Southern California Rapid Transit District  
Metro Rail Project

Analysis of  
Fireproofing Repairs  
to Main Shop Building  
Contract A112  
November 14, 1989

RM. 157- COLUMNS & K-BRACING AT GRIDLINE A-3 & A-4

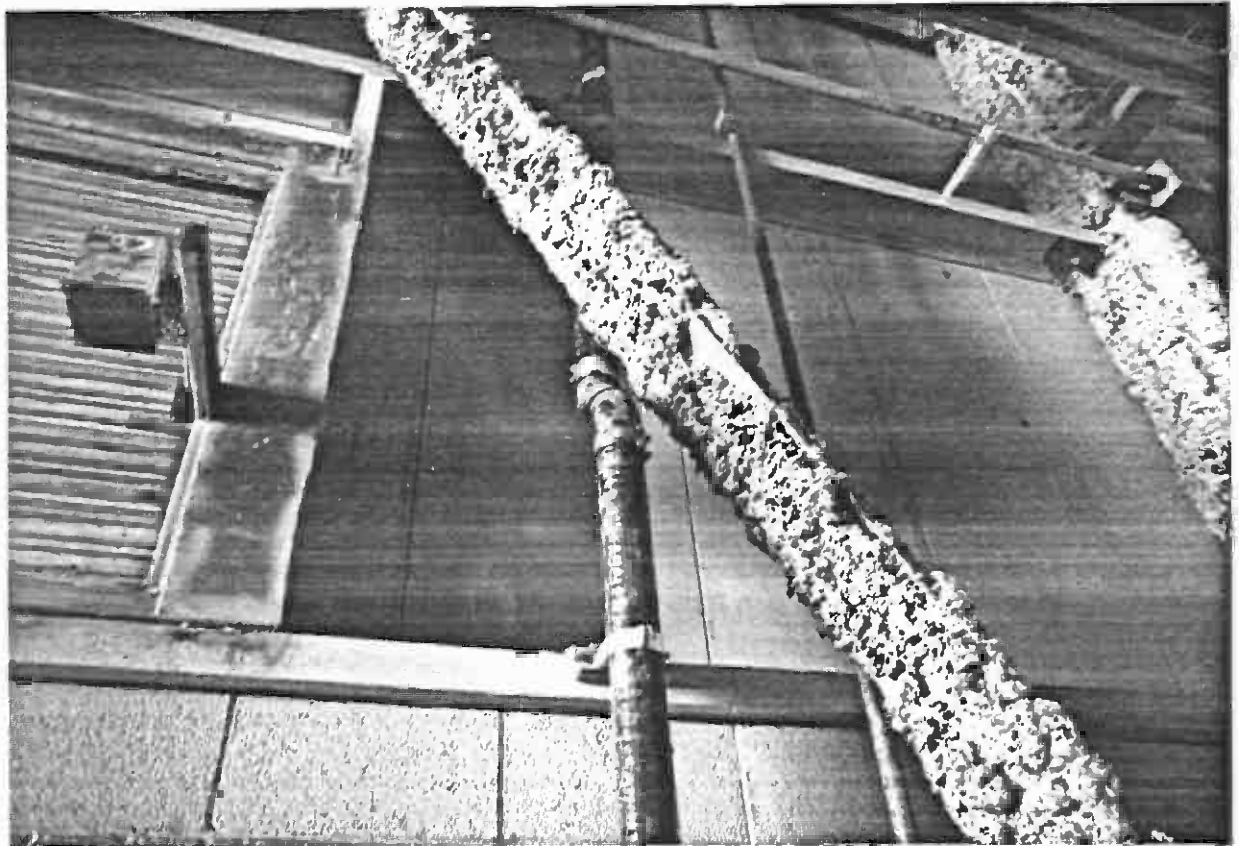
The K-braces on gridline A must be covered with a gypsum board finish for a height of 8'-0" from the floor. The miscellaneous conduits, surface mounted light fixtures,

rainwater leaders, and sprinkler system drain lines that occur on or near K-braces will have to be handled by enclosing or relocating the service to the new face of finish. (Repair Type III.) (Photos Nos. 1, 2, 3, 4.)

RM. 157- EXPOSED ROOF DECK.

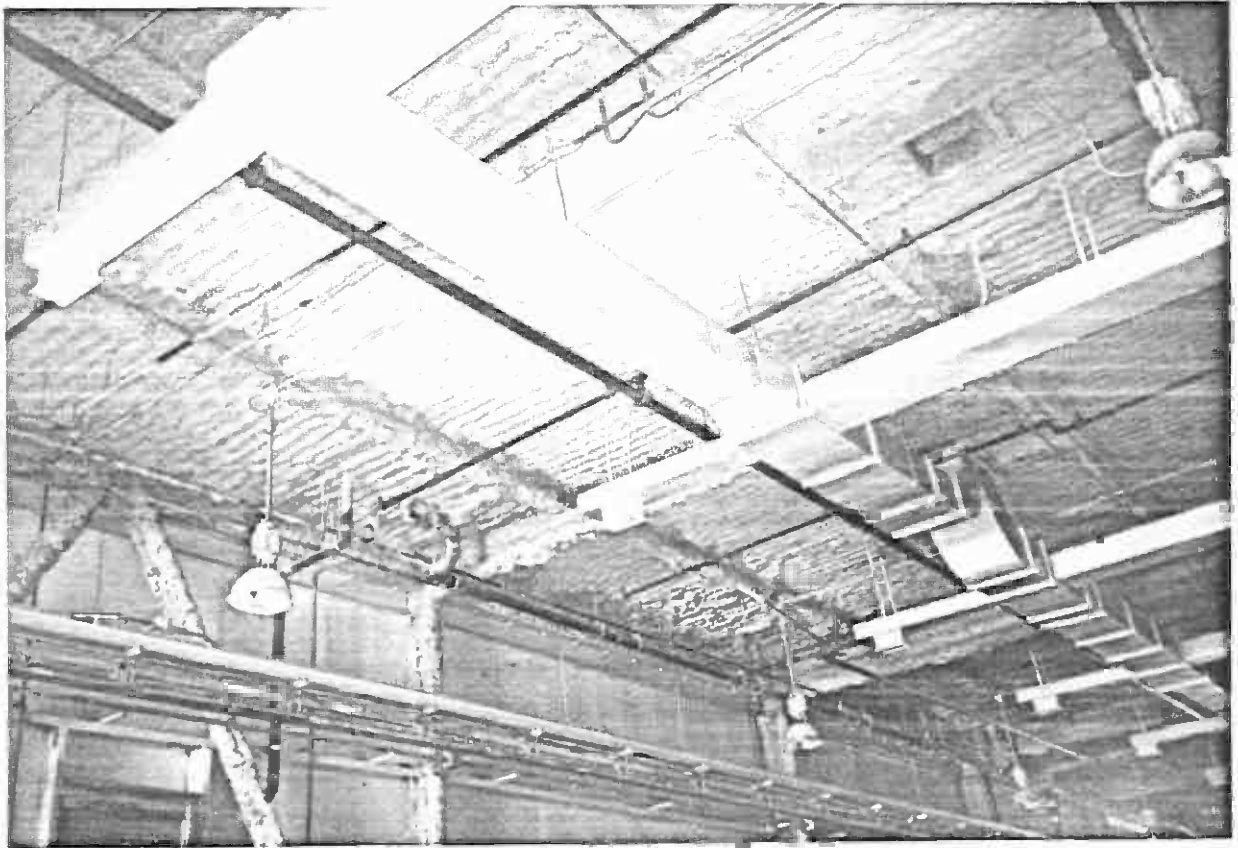
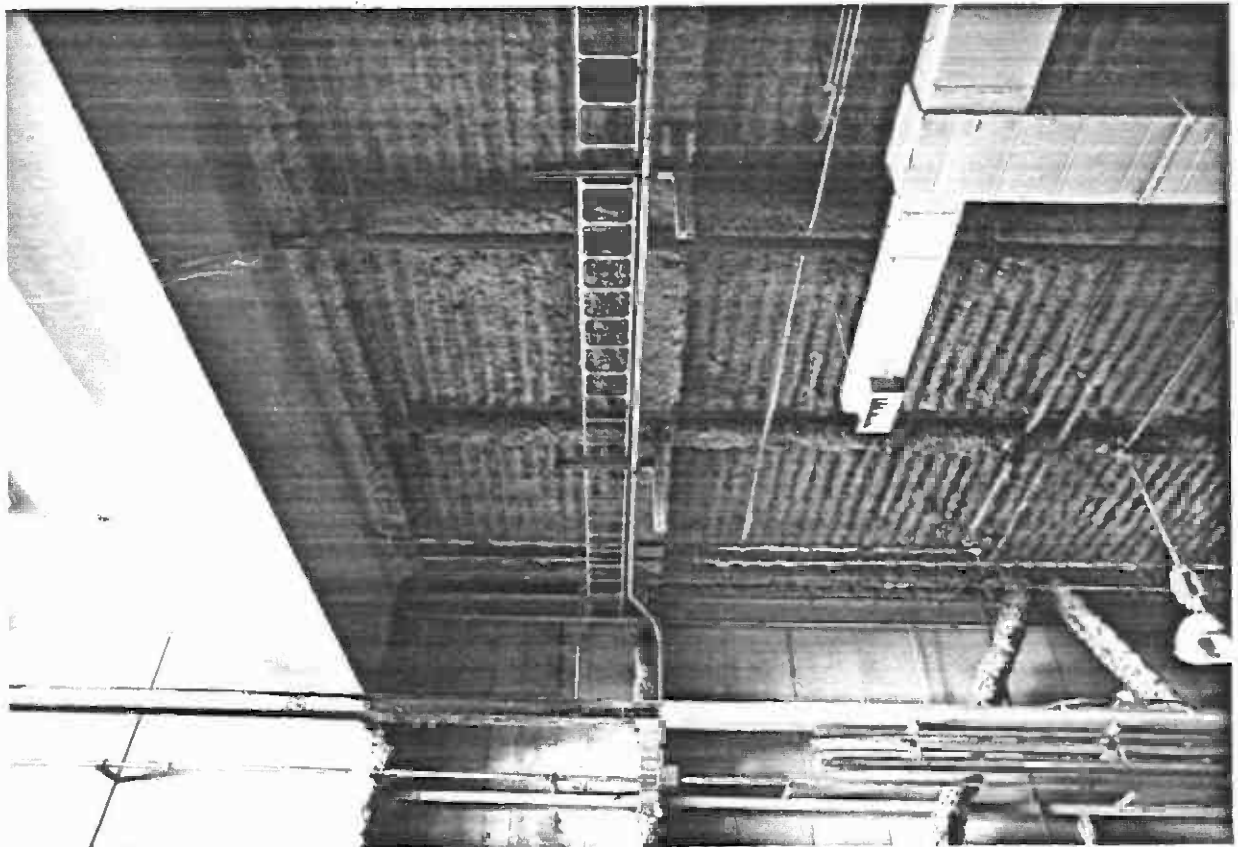
All the existing fiber-type fireproofing on the roof trusses, bottom chord diagonal bracing, purlins, and roof deck between gridlines 2.7 and 10, must be sprayed with a sealer compatible with the mineral fiber-type fireproofing. (Photos Nos. 9, 10.)

RM. 124- COLUMNS AT GRIDLINE E

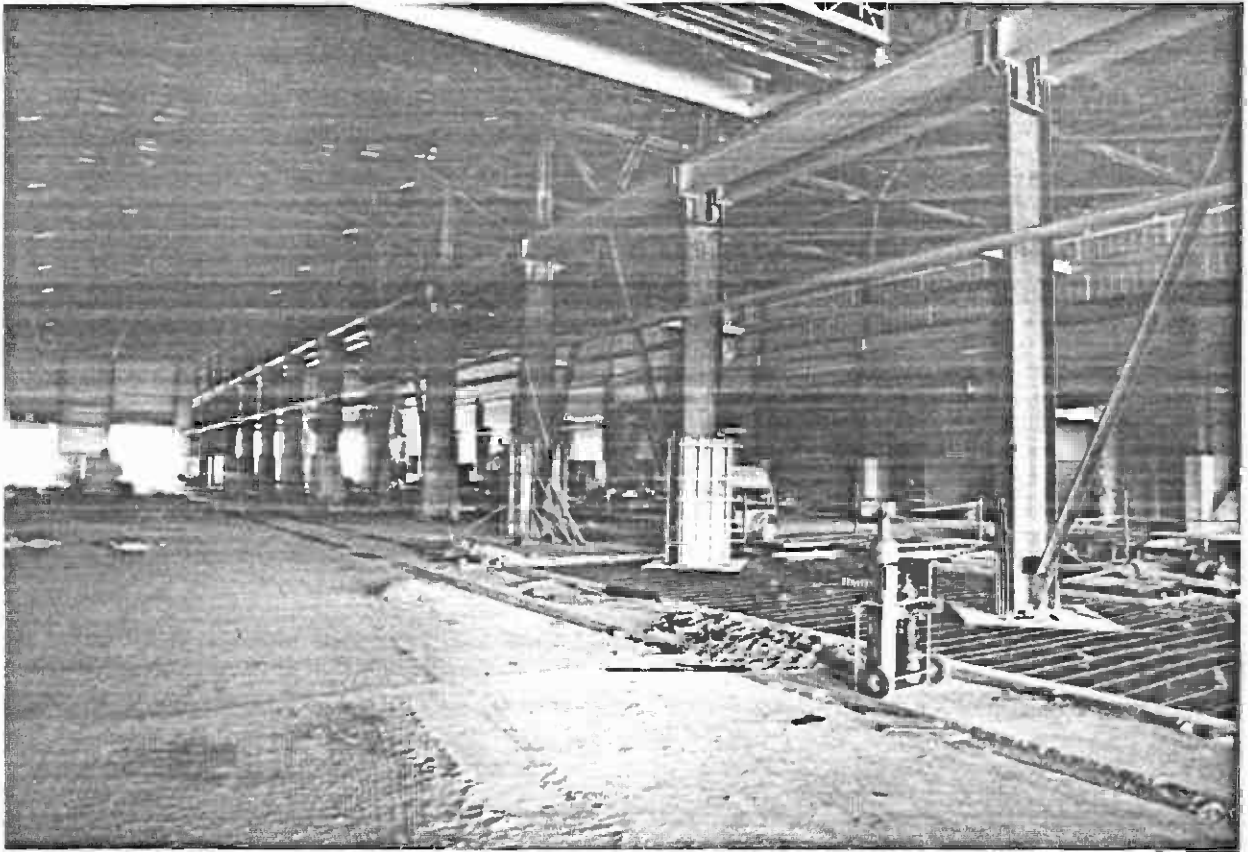
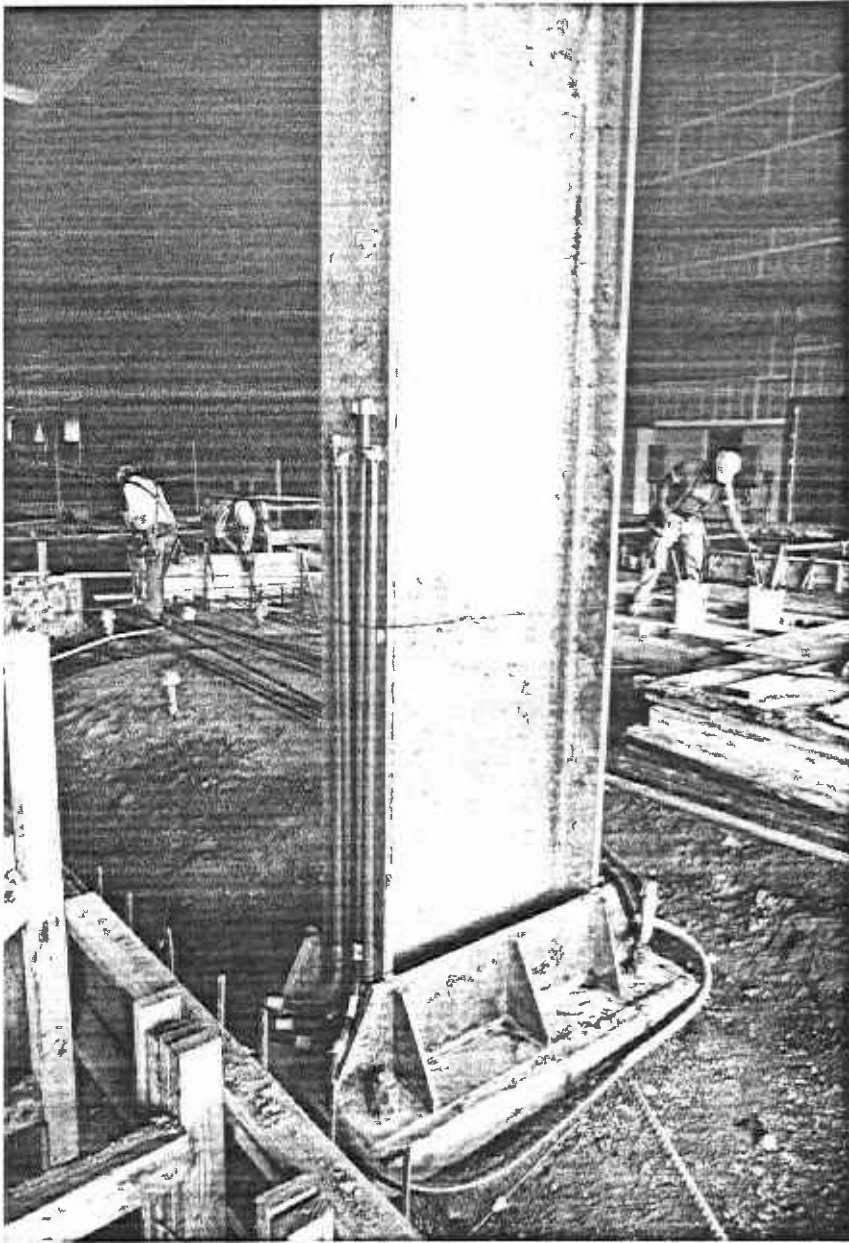
At gridline E in the Heavy Repair Shop, the columns and K-braces must be stripped of the existing fireproofing and resprayed with a cementitious-type fireproofing. The columns shall be sprayed from above the concrete encasement to the roof deck, and the K-bracing from finish floor to the bottom chord of the roof trusses. A compatible hard surface coating shall be applied over the fireproofing to provide further resistance to impact damage. This coating shall cover all fireproofing at gridline E from its lowest point of application to the height of the crane rail above. Surface mounted light fixtures, electrical outlets and fire hose cabinets and these will have to be relocated to the surface of the new finish. (Photos Nos. 32, 33, 34.)

PROTECTION OF FIREPROOFING @ GRIDLINE G	JOB No. A-112	SHEET No.
REPAIR TYPE II refer to para. IV(J)	DESIGNED BY MATHEWS	DATE
	APPROVED

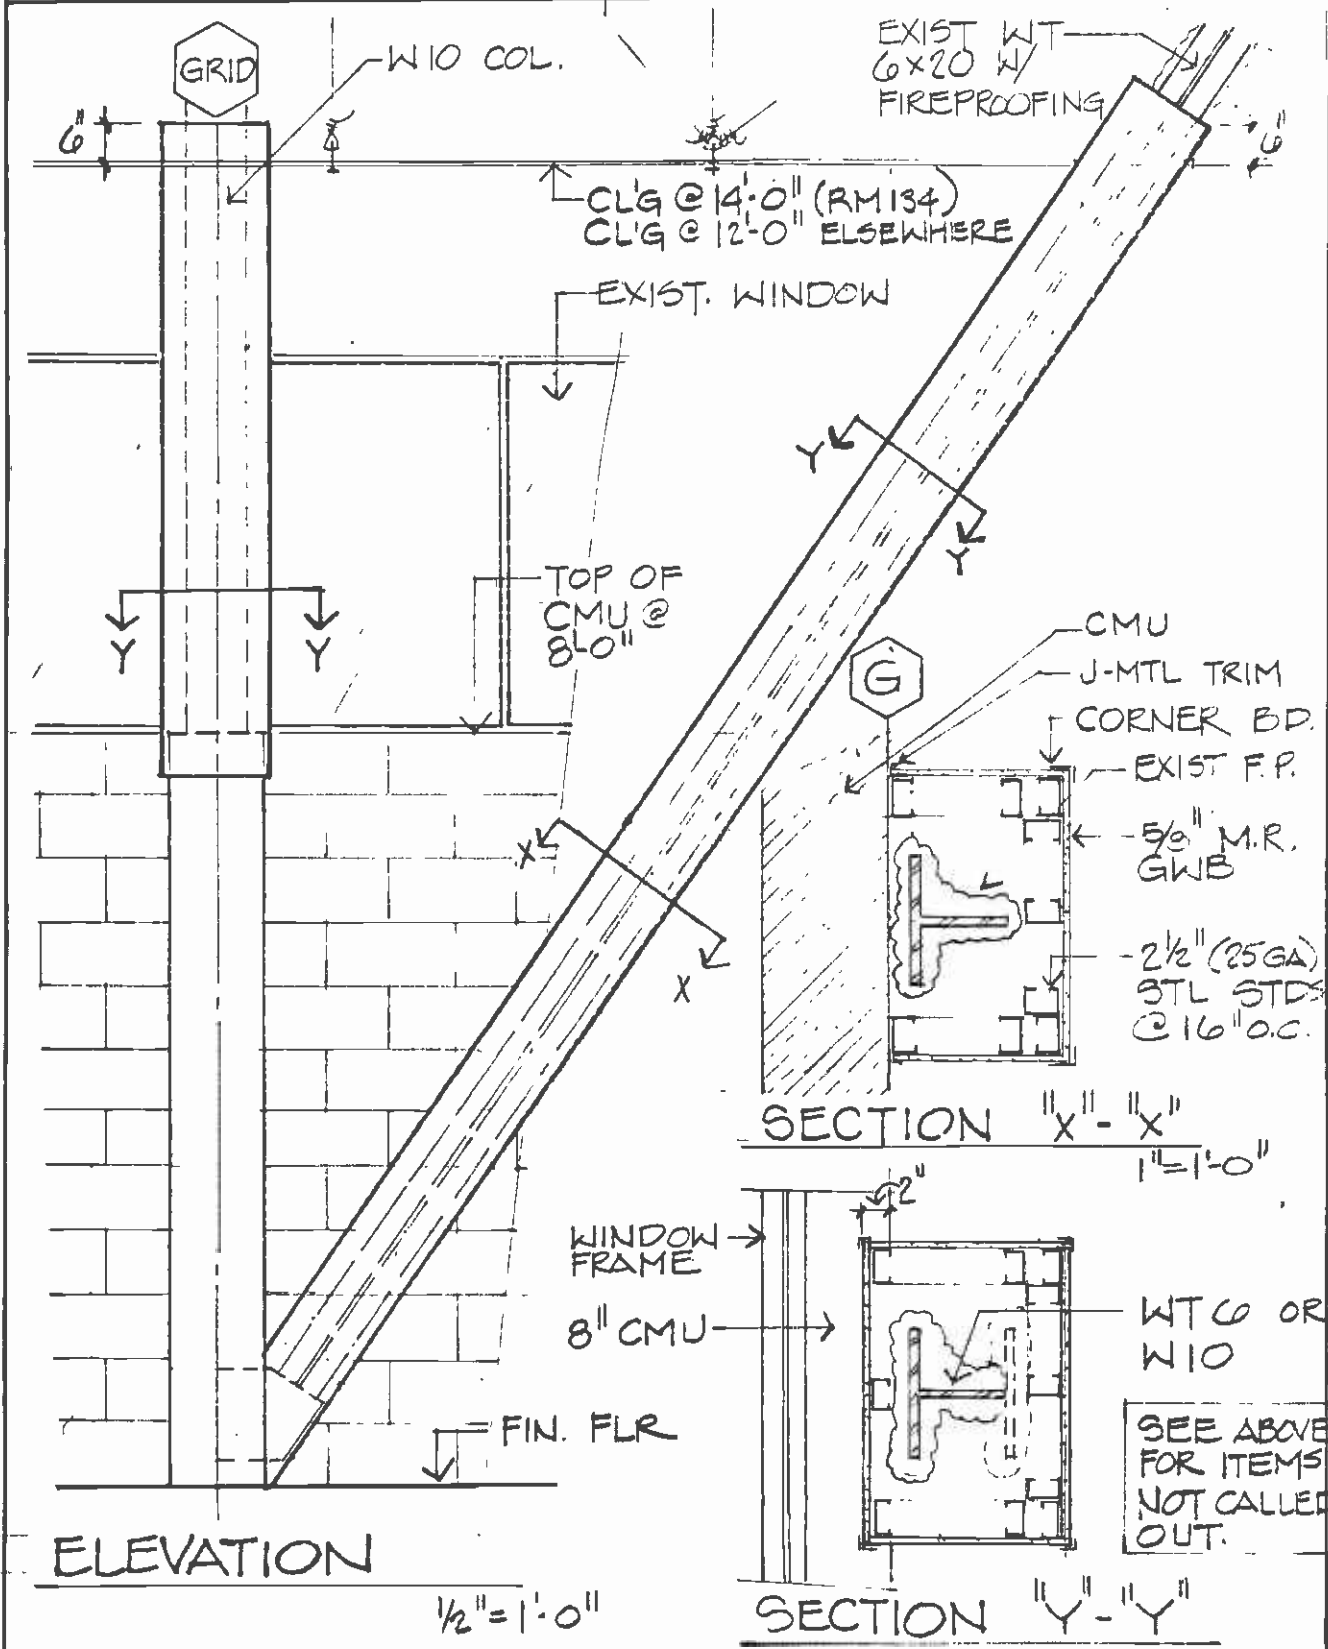
There are columns and K-bracing along gridline G in Systemwide Stores with exposed mineral fiber-type fireproofing that have been touched up with a cementitious-type fireproofing. Provide gypsum board finish on metal stud furring for columns from top of concrete encasement to steel deck above. At the K-braces provide the same gypsum board finish from finish floor to steel deck. Where columns and K-braces span across windows, the gypsum board finish shall enclose all four sides. (Repair Type II.) (Photos Nos. 59, 60, 61, 62, 63, 64.)

PROTECTION OF FIREPROOFING	JOB No. A-112	SHEET No.
	DESIGNED BY MATHews	DATE
REPAIR TYPE III refer to para IV(B,F,H)	APPROVED

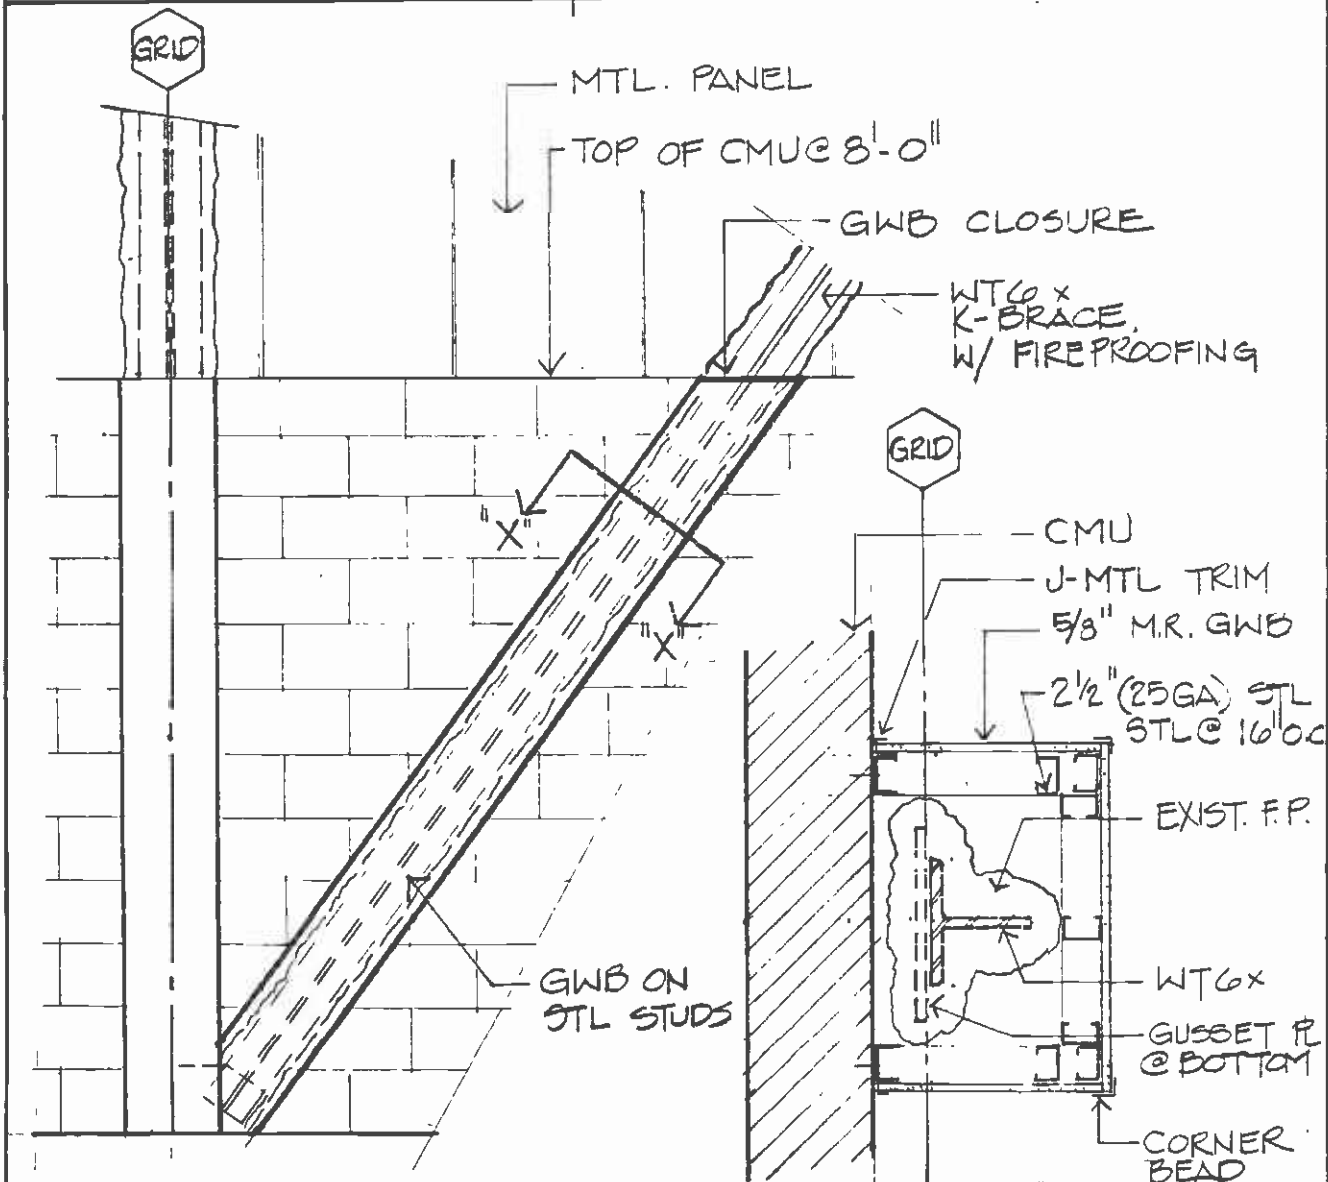
The K-bracing must be encased in gypsum board on metal furring to height of 8'-0" from finish floor. (Repair Type III.) The existing fireproofing on the steel and supporting beams must be sprayed with a compatible sealer.

In Service/Inspection the K-braces on gridlines B and C must receive a new gypsum board finish, extending to 8'-0" above finish floor. Miscellaneous conduits, surface mounted light fixtures, rain water leaders and sprinkler system check valves occurring on or near K-Braces will have to be handled by enclosing or relocating the service to the new face of finish. (Repair Type III.) (Photos Nos. 42, 43, 44, 45, 46, 47, 48.)

The K-braces on gridlines D and F in the Heavy Repair Shop shall receive the gypsum board finish extending to 8'0" above finish floor. (Repair Type III. Photos Nos. 24, 25, 26, 27, 28, 29, 30, and 31.)
